JOINT PUBLIC HEARING
THE CITY COUNCIL CITY AND THE PLANNING AND ZONING COMMISSION OF
THE CITY OF PEARLAND, TEXAS,
MONDAY, JULY 21, 2014, AT 6:30 P.M.
COUNCIL CHAMBERS - CITY HALL-3519 LIBERTY DRIVE

Zone Change Application No. 2014-11Z

Memo

Re: Zone Change Application Number 2014-11Z

Exhibit D Design Plan

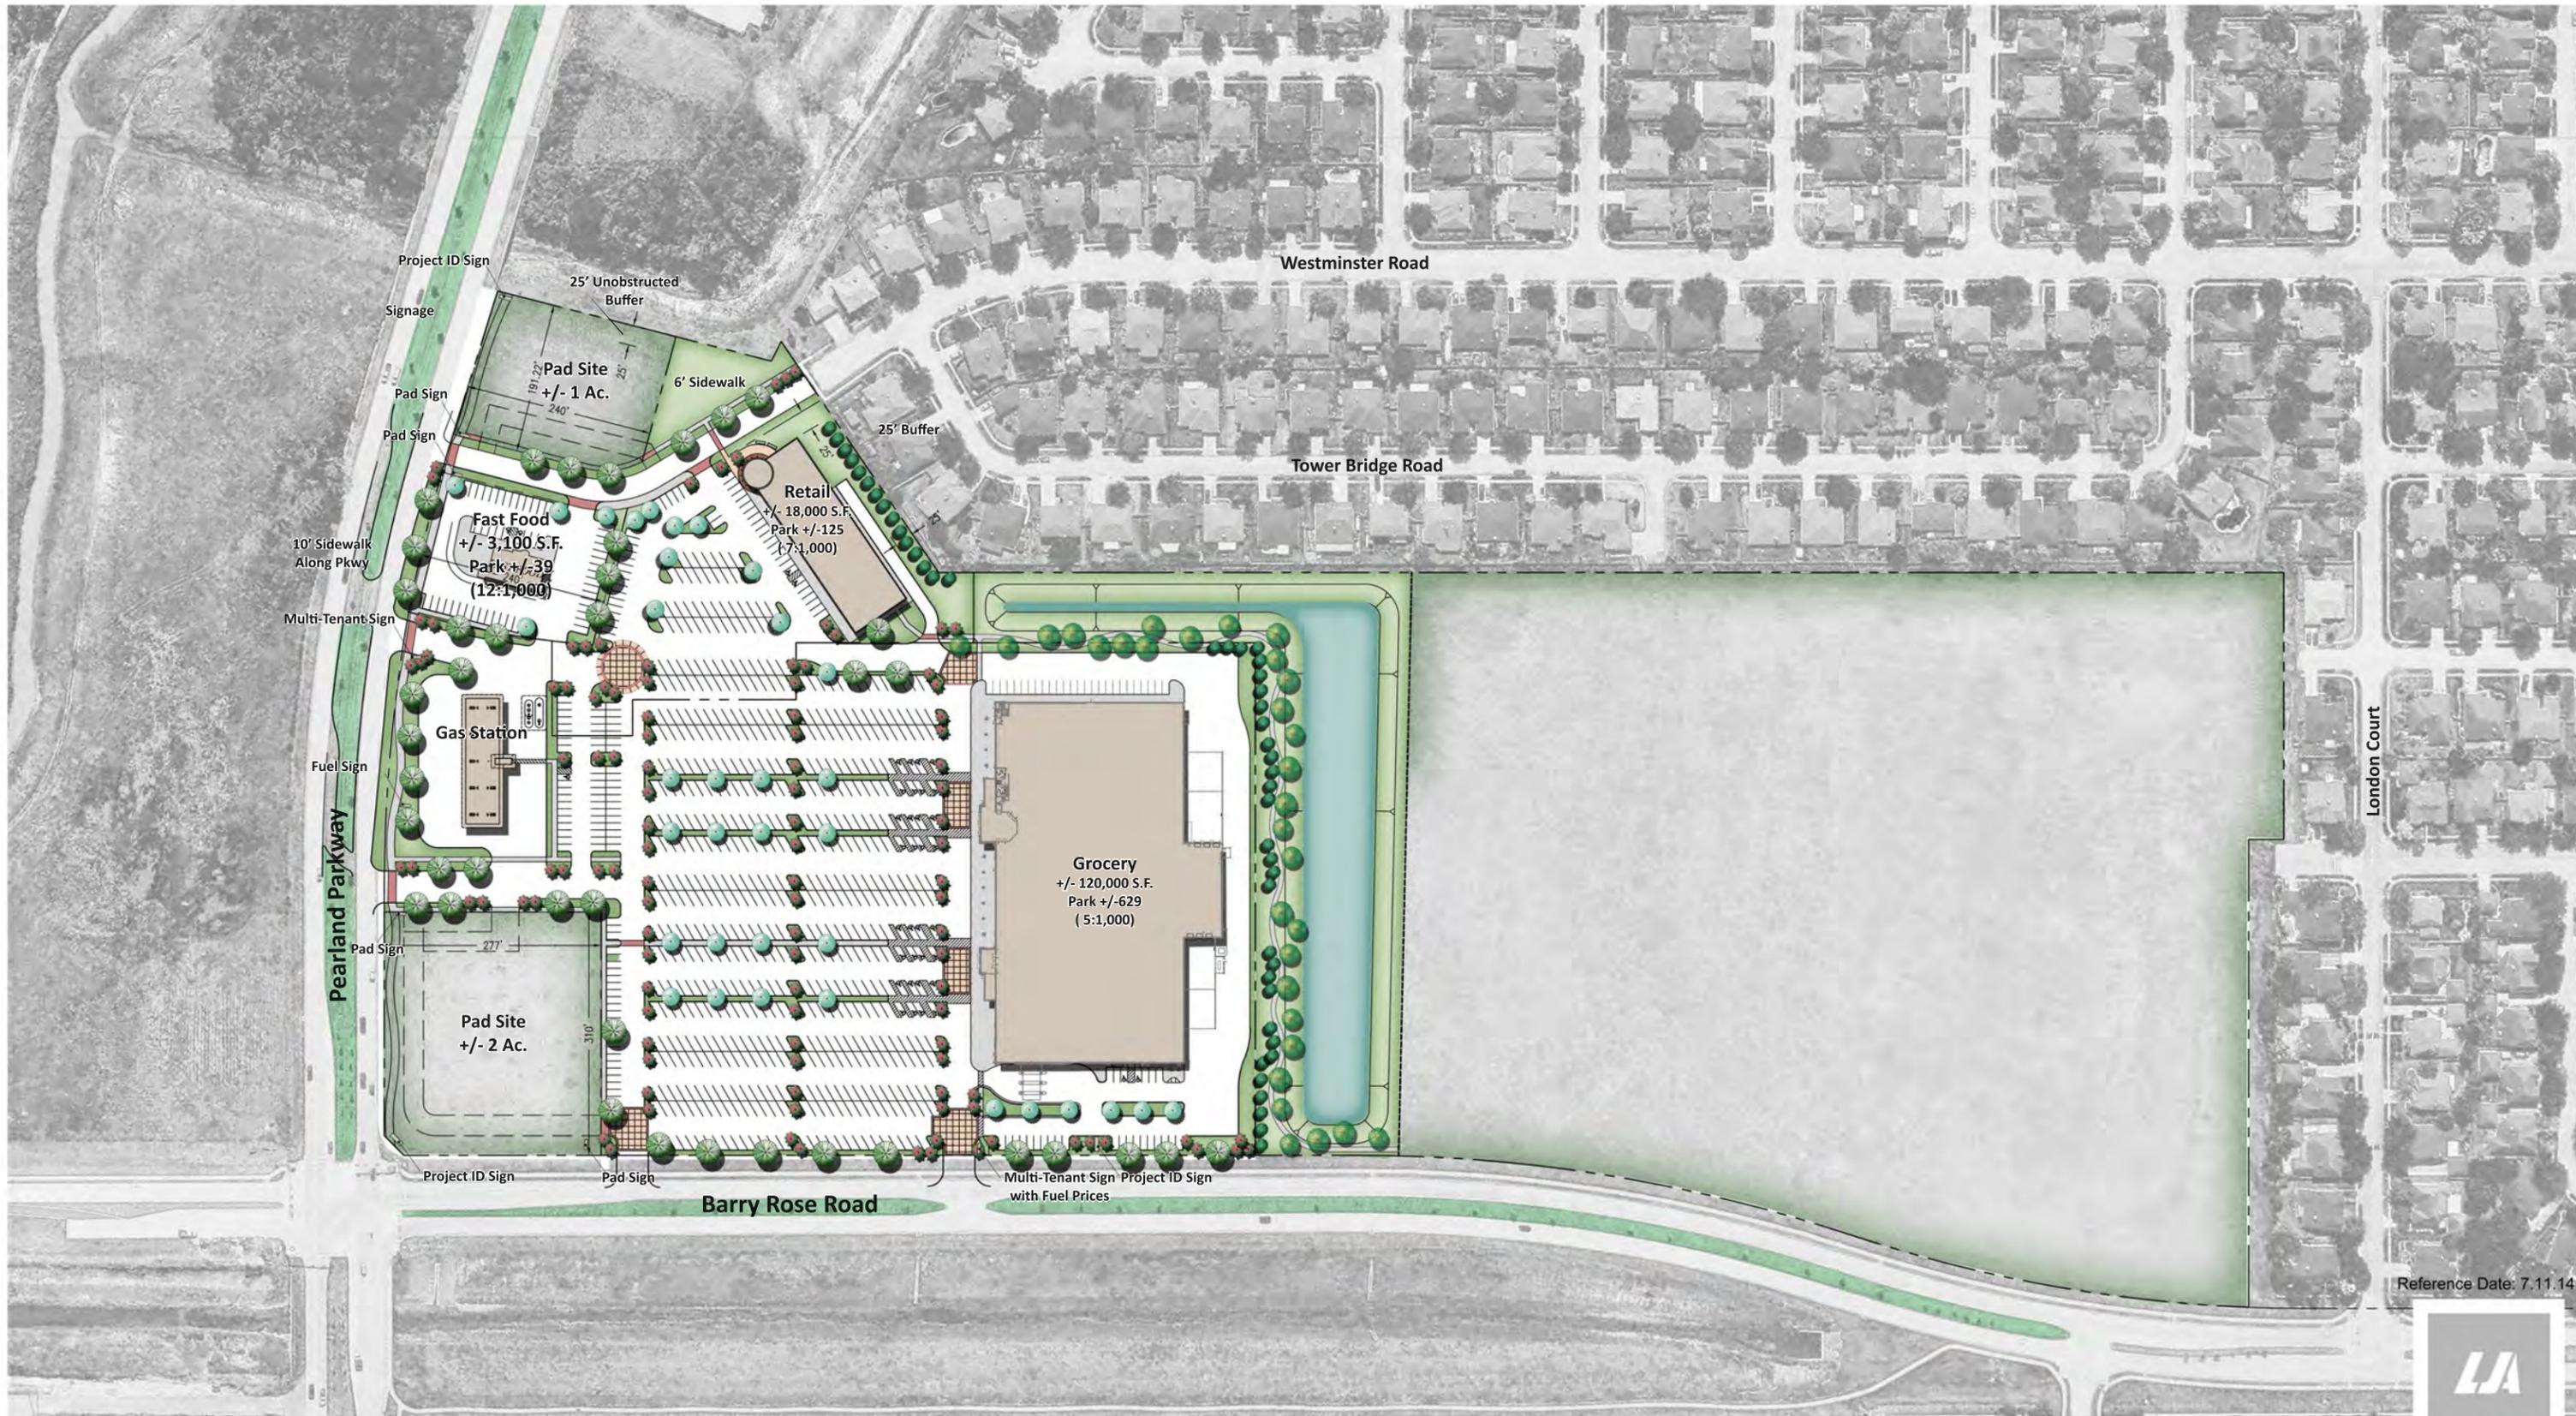
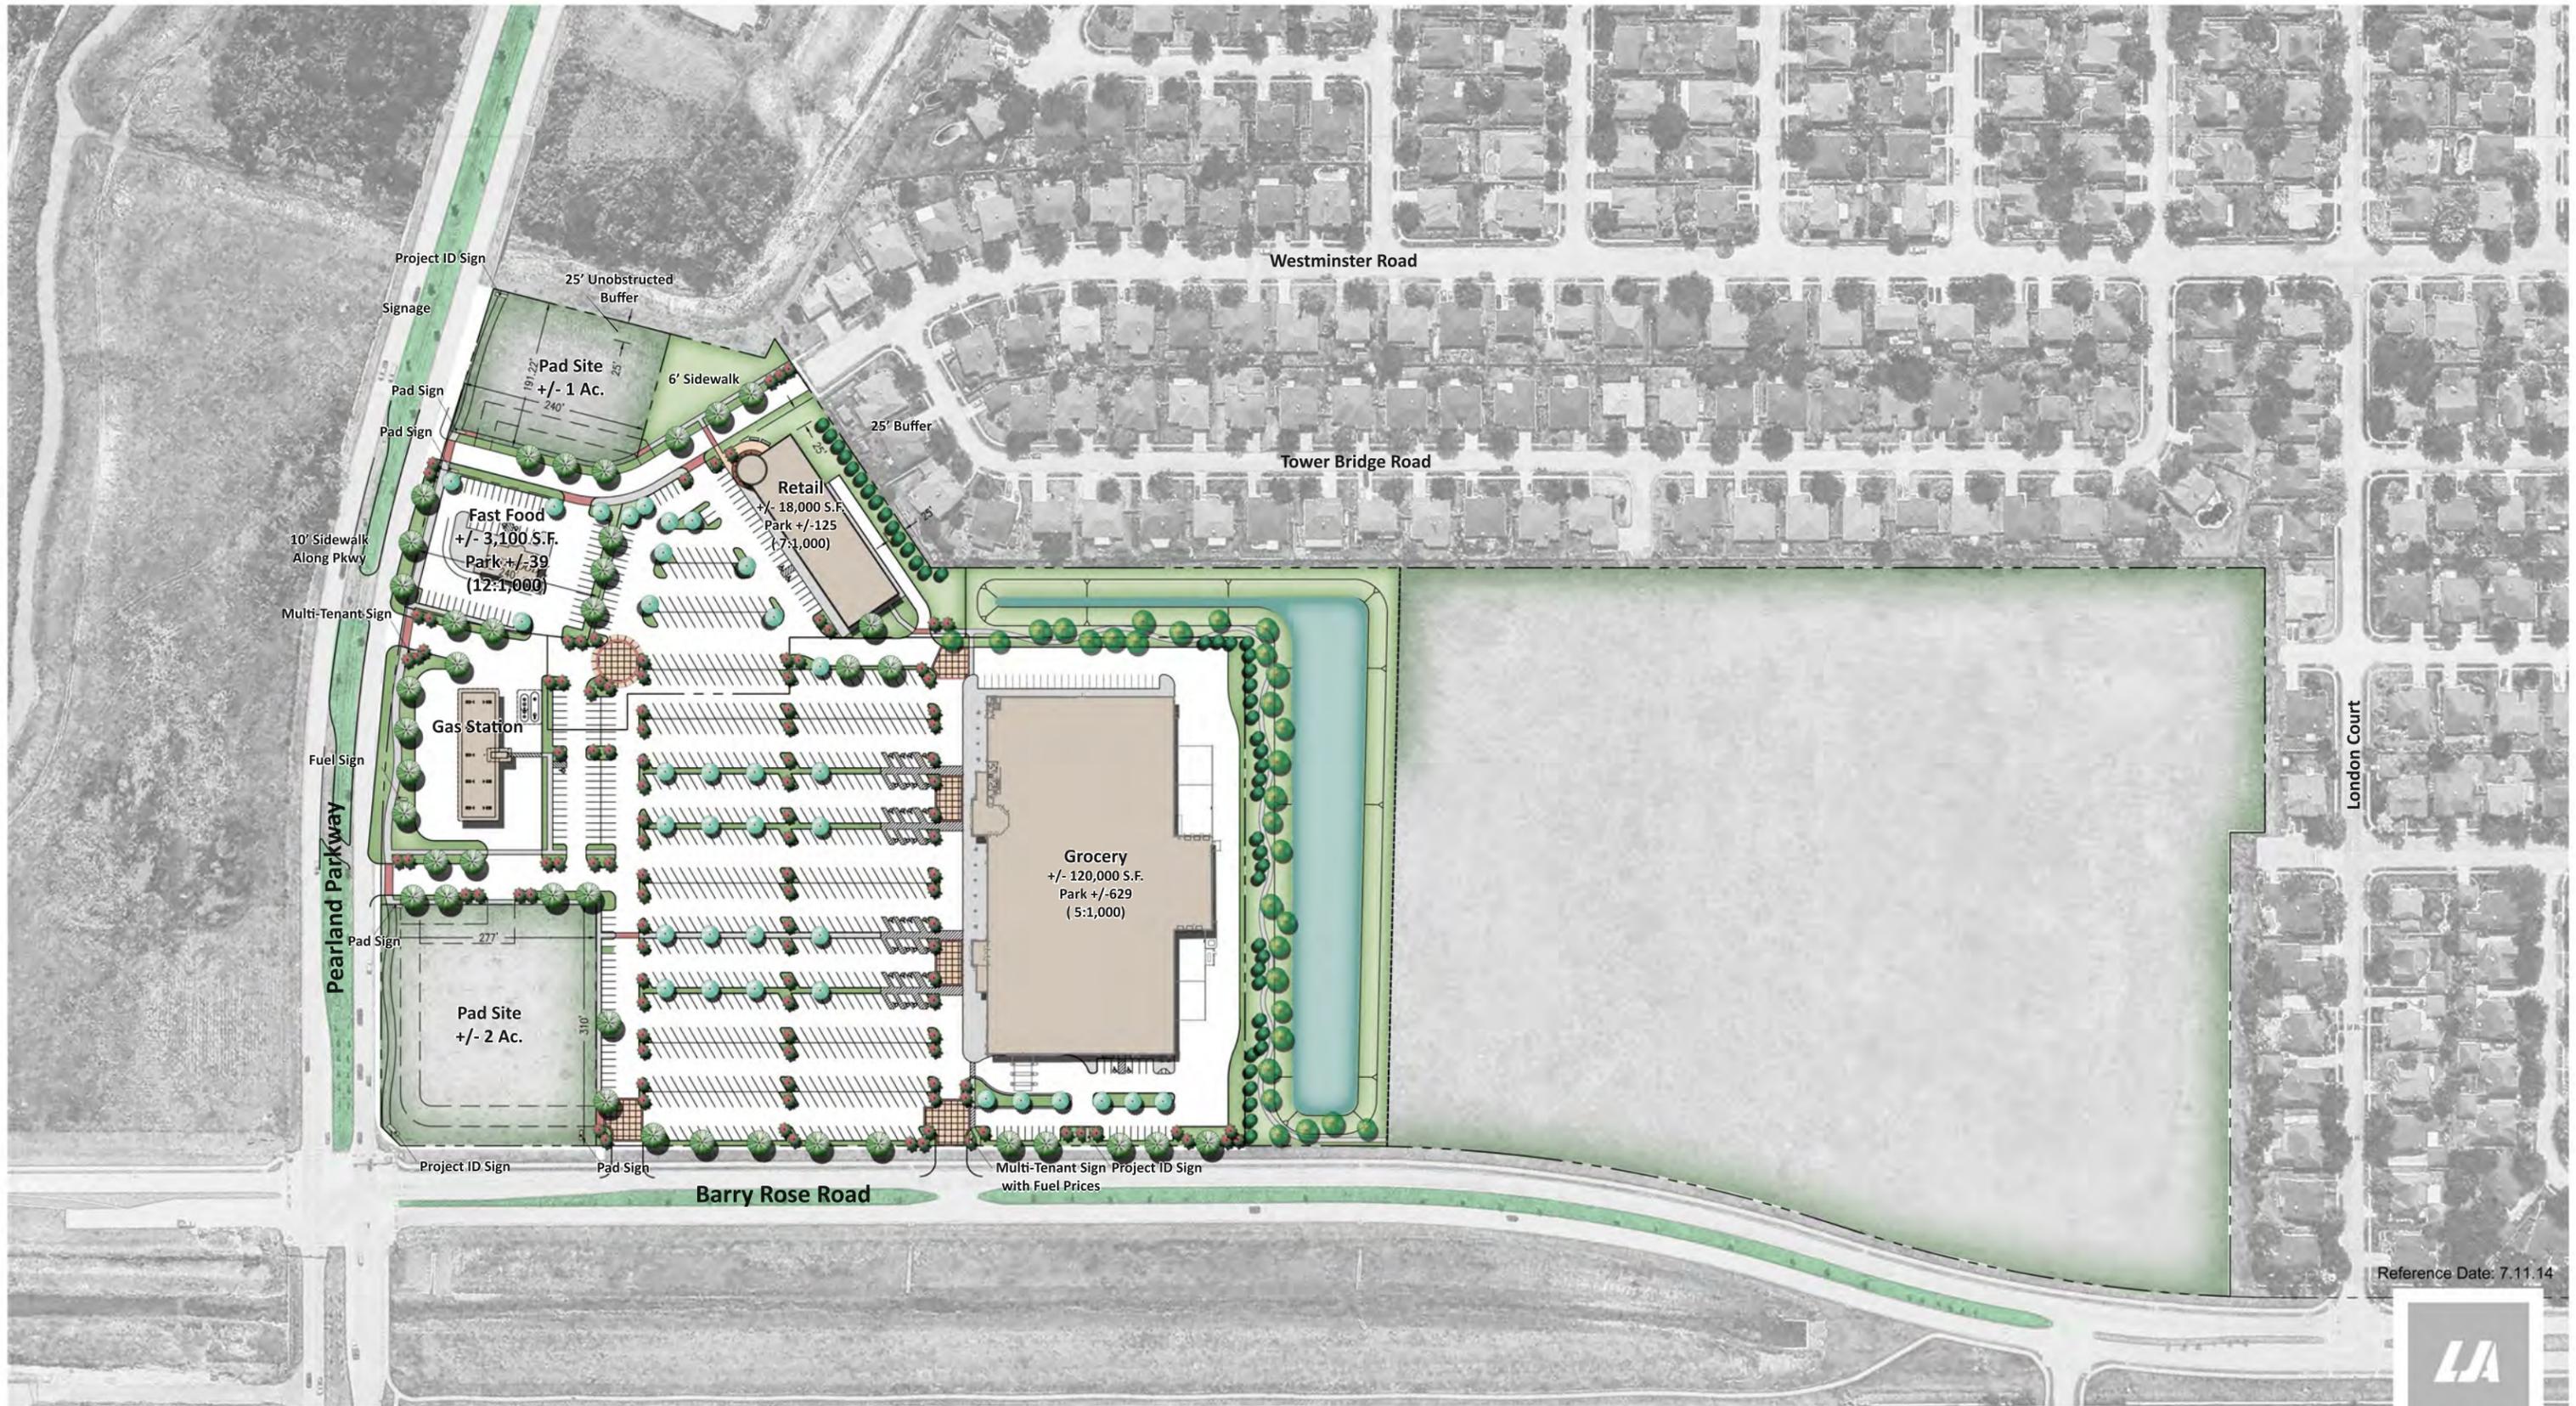
- North arrow needs to be corrected.
- Page numbers within the PD document are off.
- Codification of enhancements that are mentioned throughout the PD and illustrated in the design plan, Exhibit E (Special Paving Images) and Exhibit G (Site Furnishings) to ensure that staff is able to implement the design standards.

- A legend should be included on the design plan to ensure that staff can implement the standards.
- Clarification of the lighting standards is required. The PD states that the lighting height will be a maximum of 20 feet. This section goes on to state that no pole shall be taller than the height of the building.

- North arrow needs to be corrected.
- Page numbers within the PD document are off.
- Codification of enhancements that are mentioned throughout the PD and illustrated in the design plan, Exhibit E (Special Paving Images) and Exhibit G (Site Furnishings) to ensure that staff is able to implement the design standards.

- A legend should be included on the design plan to ensure that staff can implement the standards.
- Clarification of the lighting standards is required. The PD states that the lighting height will be a maximum of 20 feet. This section goes on to state that no pole shall be taller than the height of the building.
- The PD references enhanced street lighting. A street lighting exhibit is required to ensure that the standards of the PD can be implemented by staff.
